Project: GVR Del Sol Clubhouse Comments
Green Valley, AZ
Delta #1 Pre-Bid Comments
CC Job #23052

Del Sol Clubhouse RFIs

ADDENDUM 01

Project: Green Valley Recreation Center – Del Sol Clubhouse – Tenant Improvement

S1.3

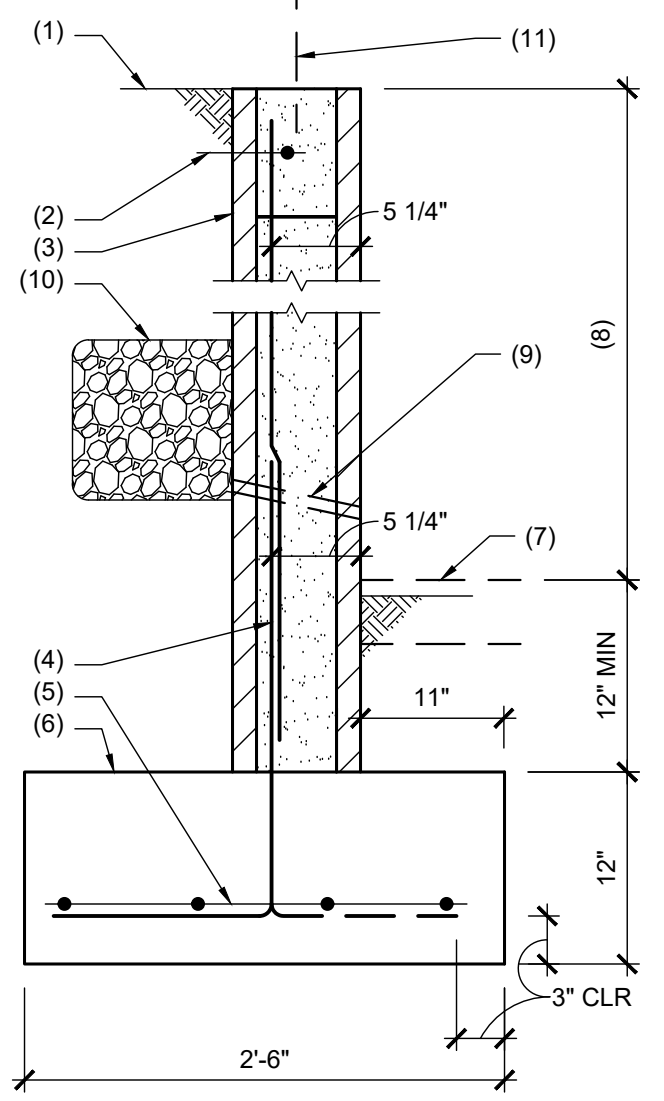
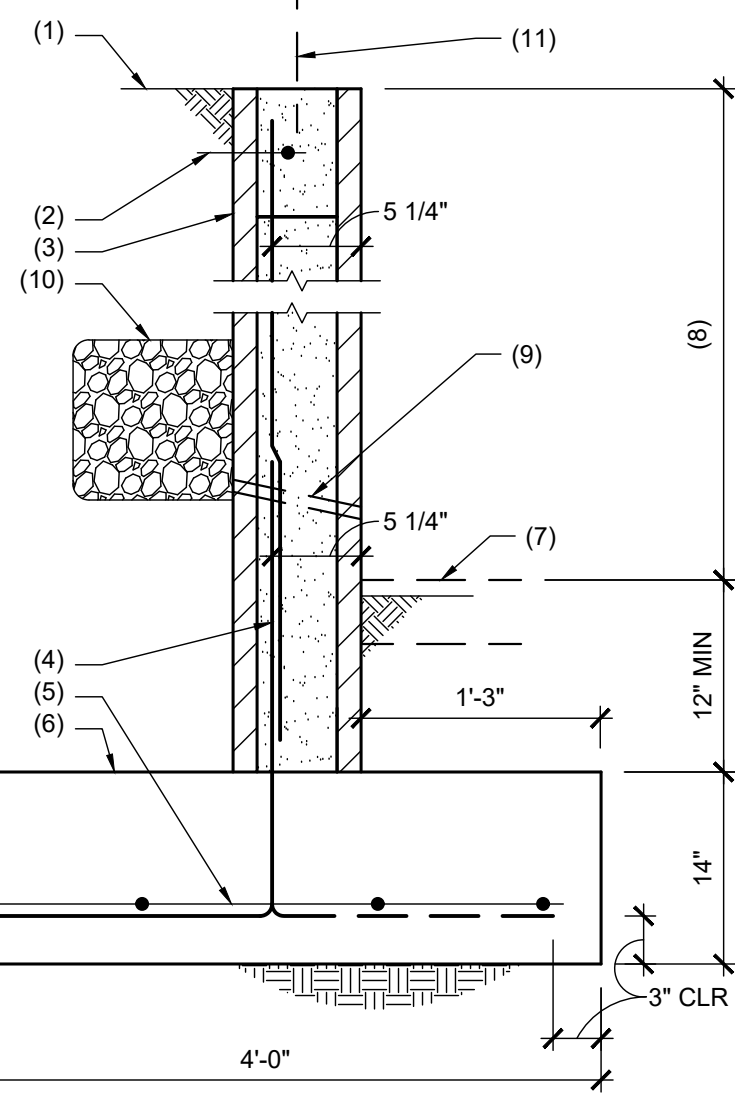
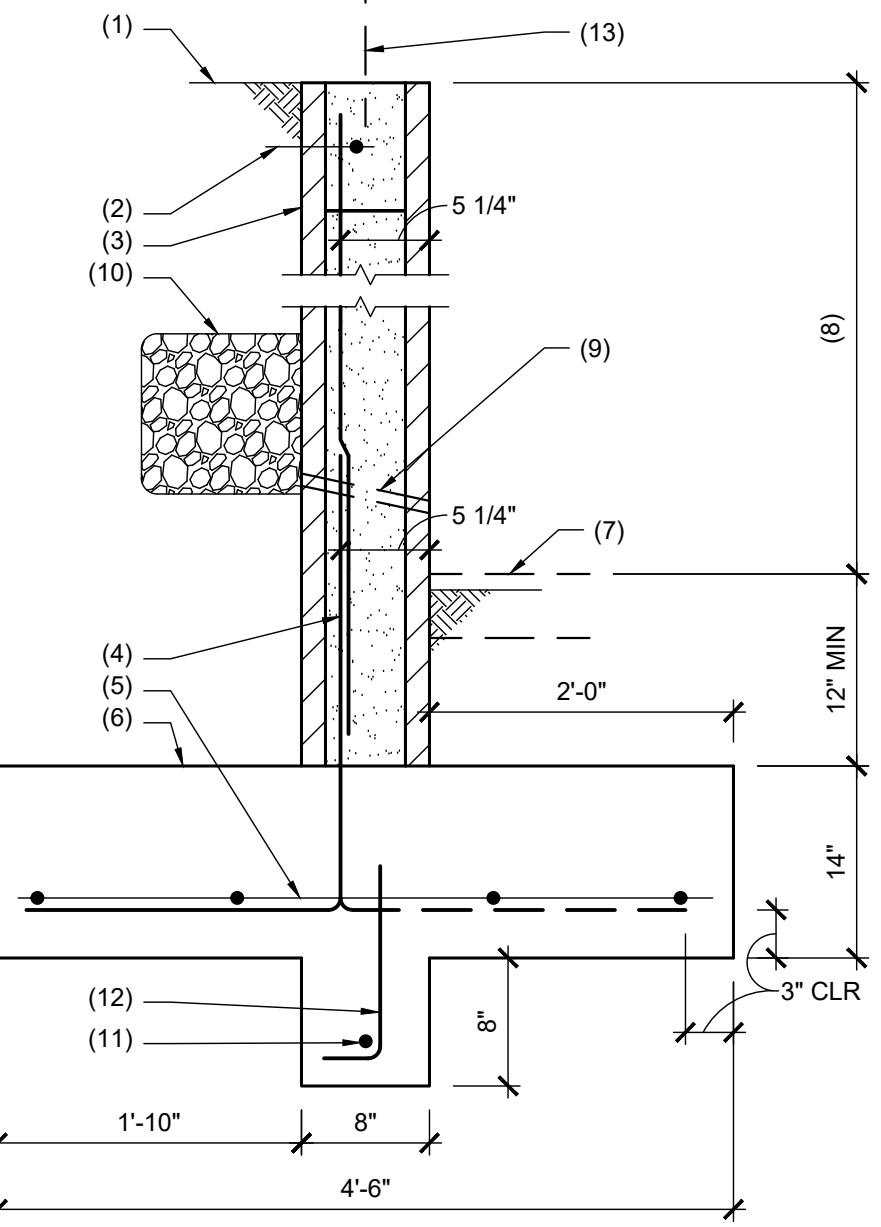
13. Will the Client contracted landscaping contractor provide irrigation sleeving if required under new hardscape? *All landscaping/irrigation and sleeving will be provided by owner.*
14. Please provide plans/details for the retaining wall (denoted as “under separate permit).” *Please find attached new sheet S1.3 showing the retaining wall details.*
